ADDENDUM # 1

RFQ 7575502

**TITLE: Interior Renovations RIAG Building 150 South Main Street,
Providence**

This Addendum forms a part of the Contract Documents and modifies the Drawings and Project Manual as hereinafter indicated.

Drawing No. ED101

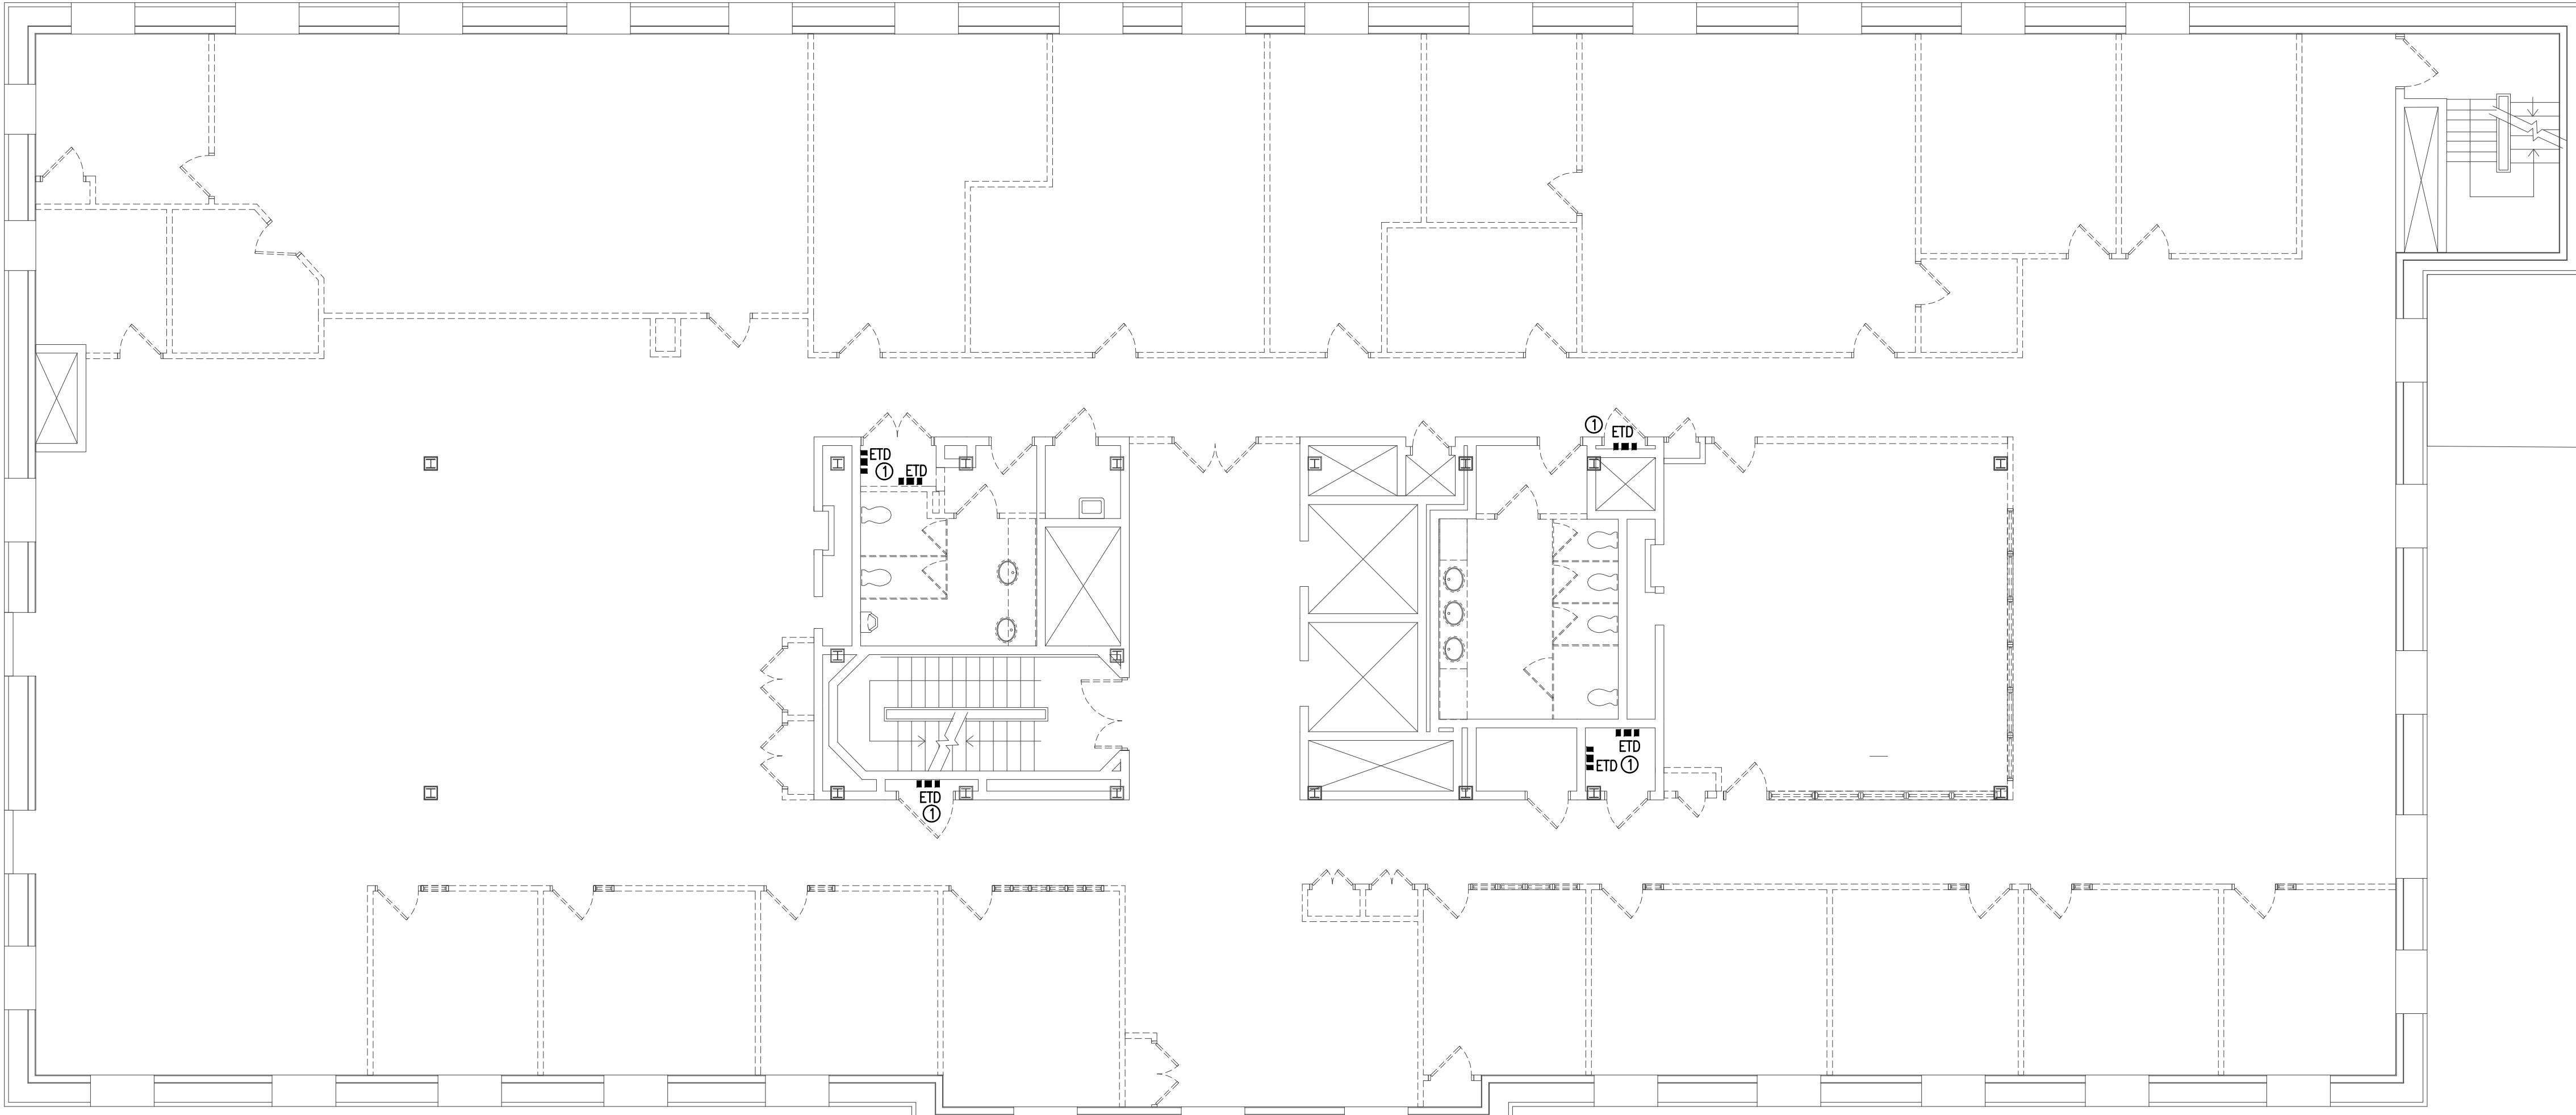
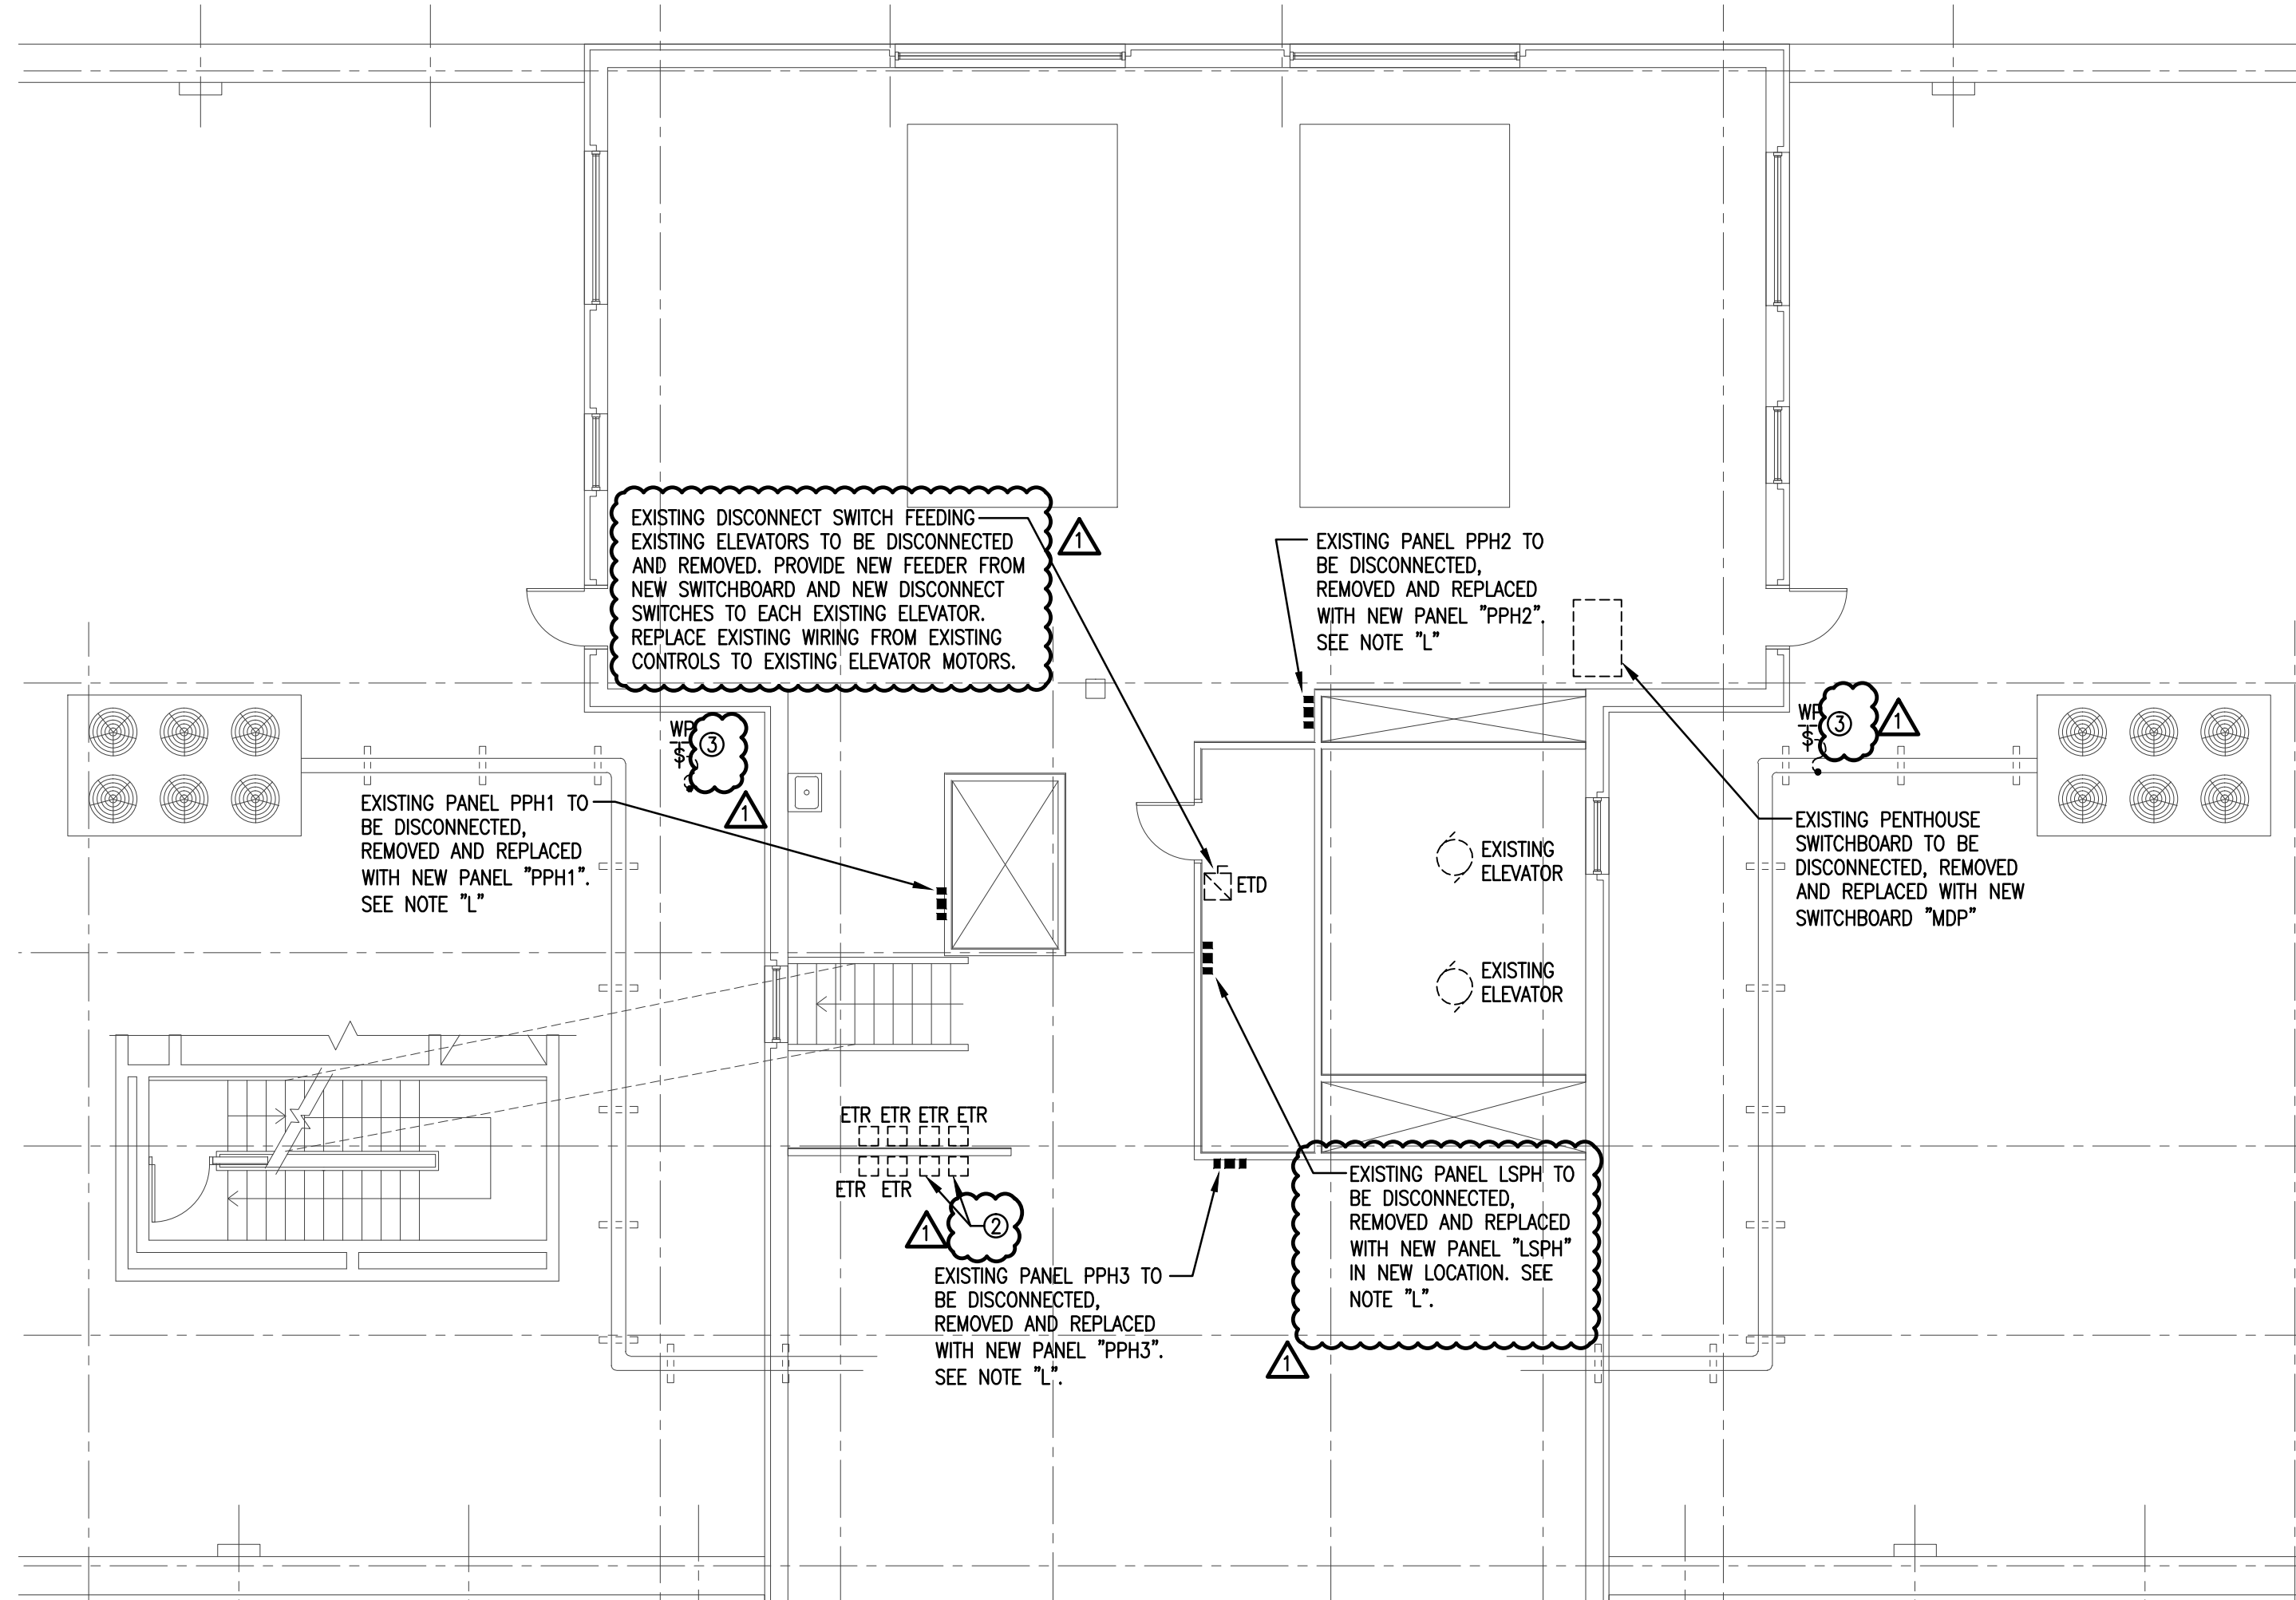
4. Drawing #ED101:
 - A. Keynote clarification.
 - B. Indicate existing feeder to existing elevators to be replaced with new feeders.
5. Drawing #E100:
 - A. Clarify disconnect switch rating at FPT-10.
